11 Coolawin Road, Avalon Beach

Comments on Updates to Plans

New Granny Flat at 11 Coolawin Road, Avalon Beach

SITE PLAN – showing test locations

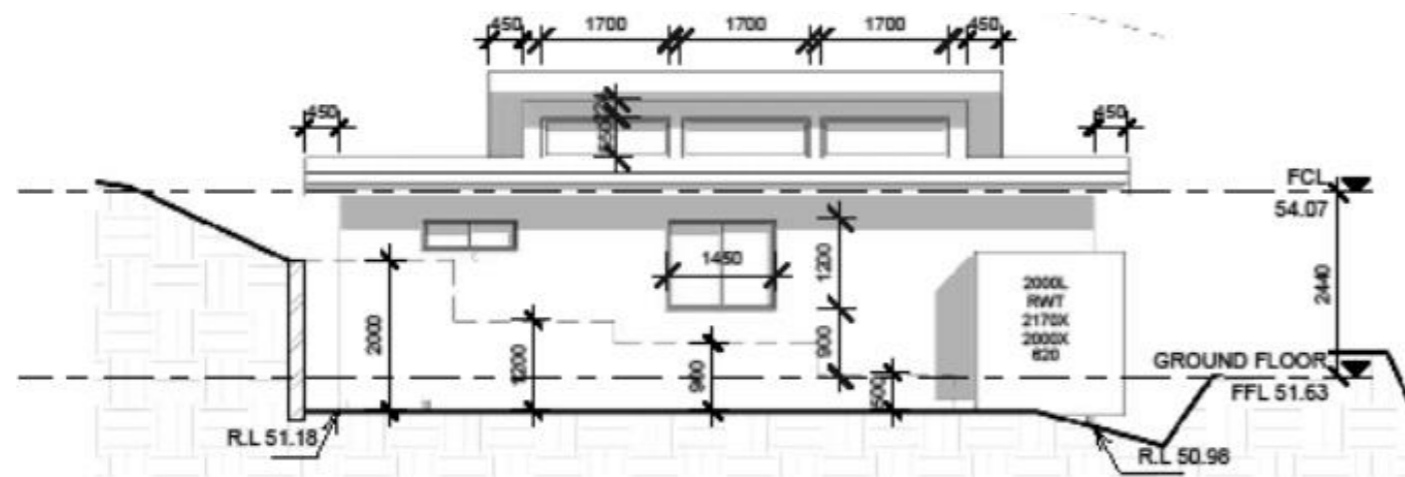
If the wall is found to be supported below the base of the proposed excavation, the excavation may commence. If it is not supported below the base of the proposed excavation, the wall will need to be underpinned prior to the excavation commencing. See the site plan attached showing the minimum extent of the required exploration pits/underpinning.

Minimum extent of required exploration pits/underpinning shown in blue

TYPE SECTION – Diagrammatical Interpretation of expected Ground Materials

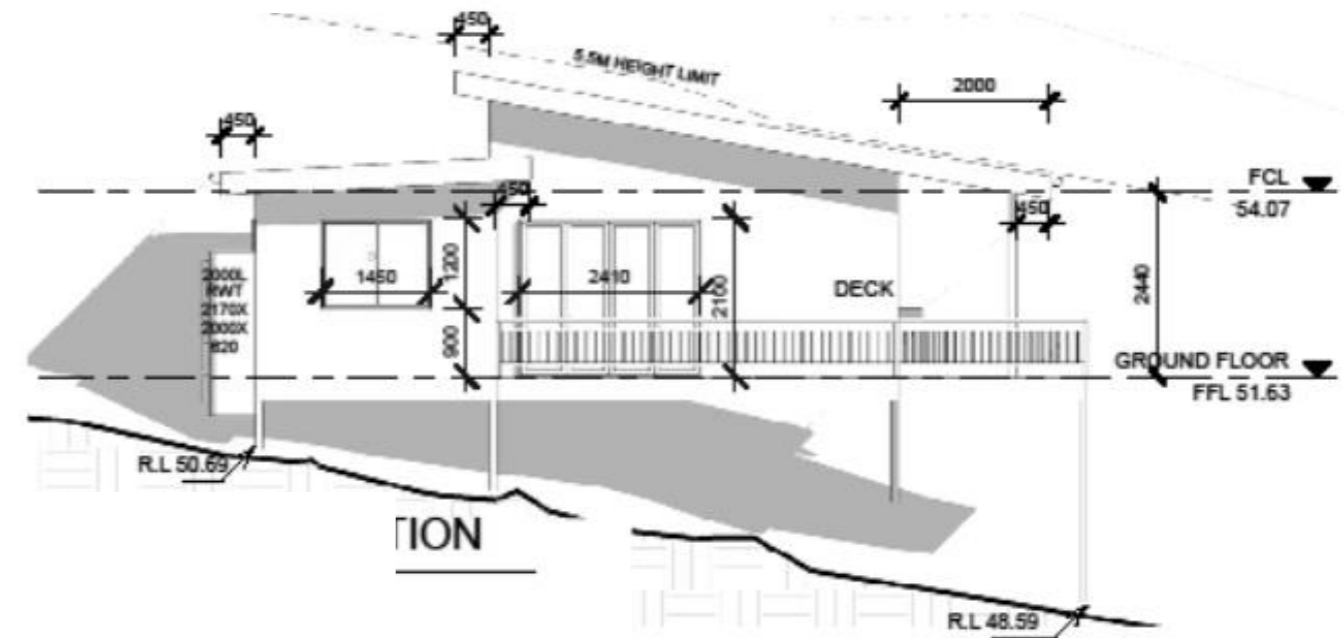
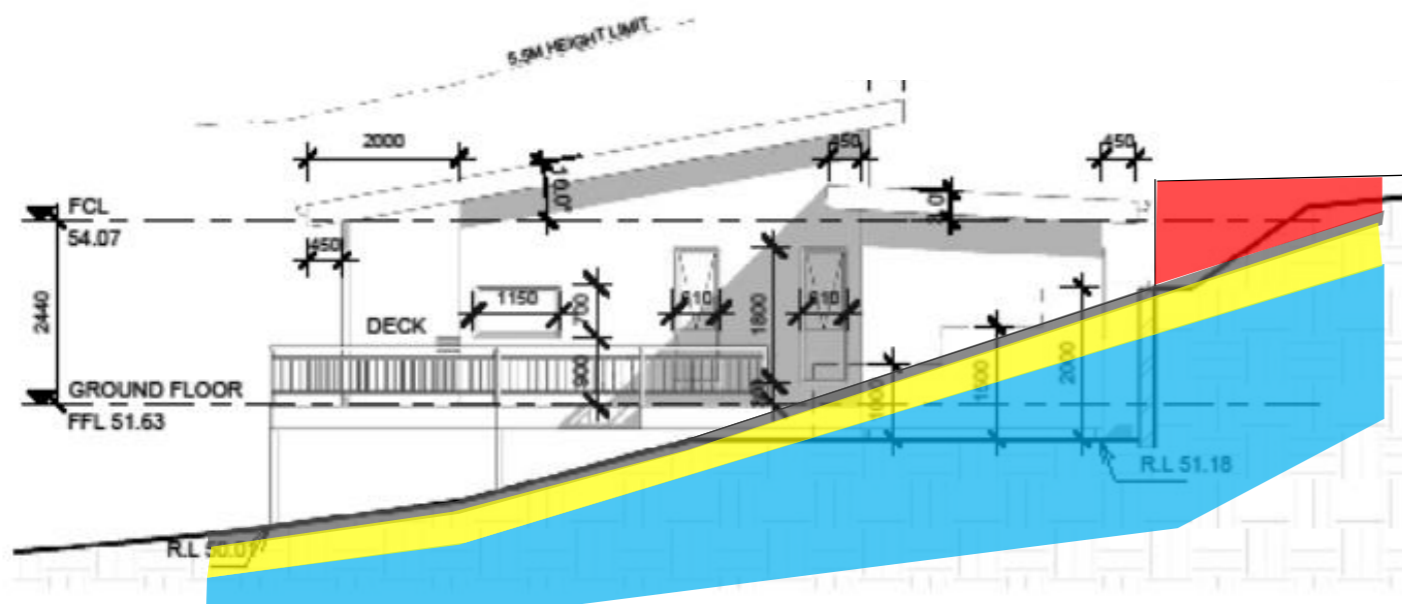
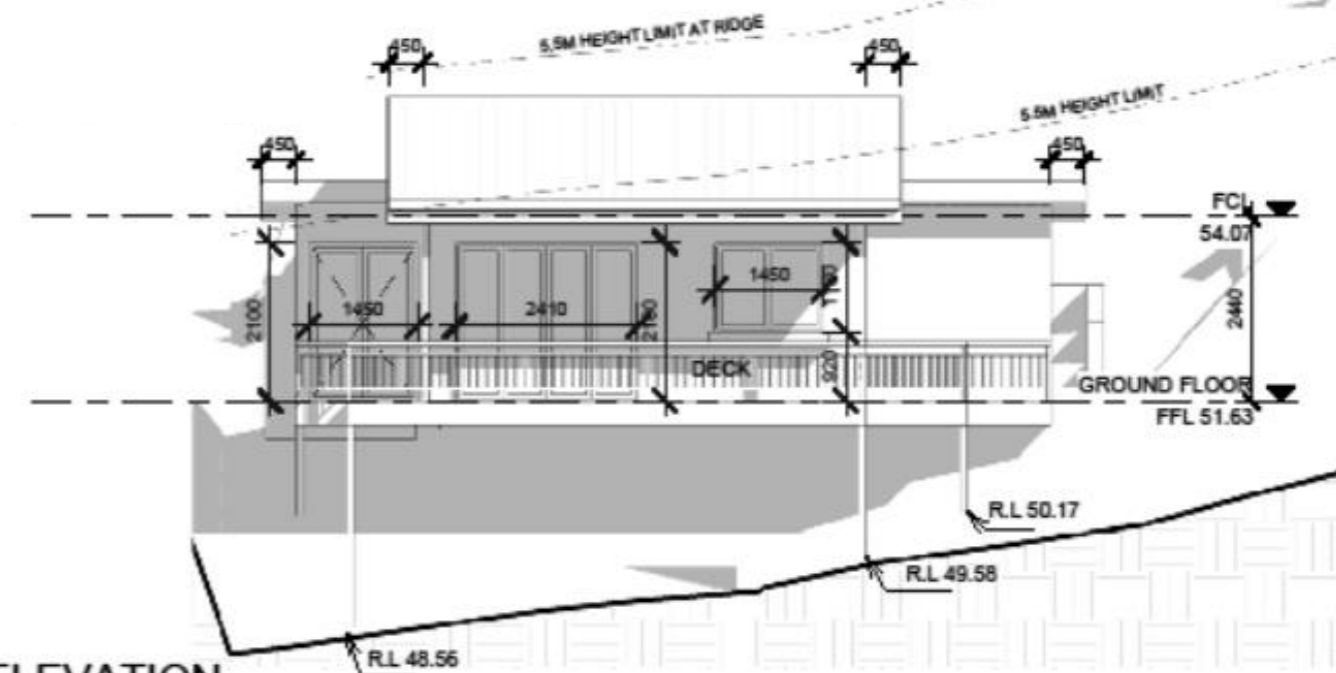
The slope materials are colluvial at the near surface and residual at depth. In the test locations, the ground materials consist of a thin silty soil over firm to hard silty clays. The silty clays merge into the underlying weathered rock at an average depth of ~0.6m below the current surface in the location of the proposed granny flat. The weathered zone is interpreted to be Extremely Low to Very Low Strength Shale. See Type Section attached for a diagrammatical representation of the expected ground materials.

- Fill
- Topsoil
- Silty Clay – Firm to Hard
- Narrabeen Group Rocks – Extremely Low Strength Shale - after being cut up by excavation equipment can resemble a stiff to hard clay.
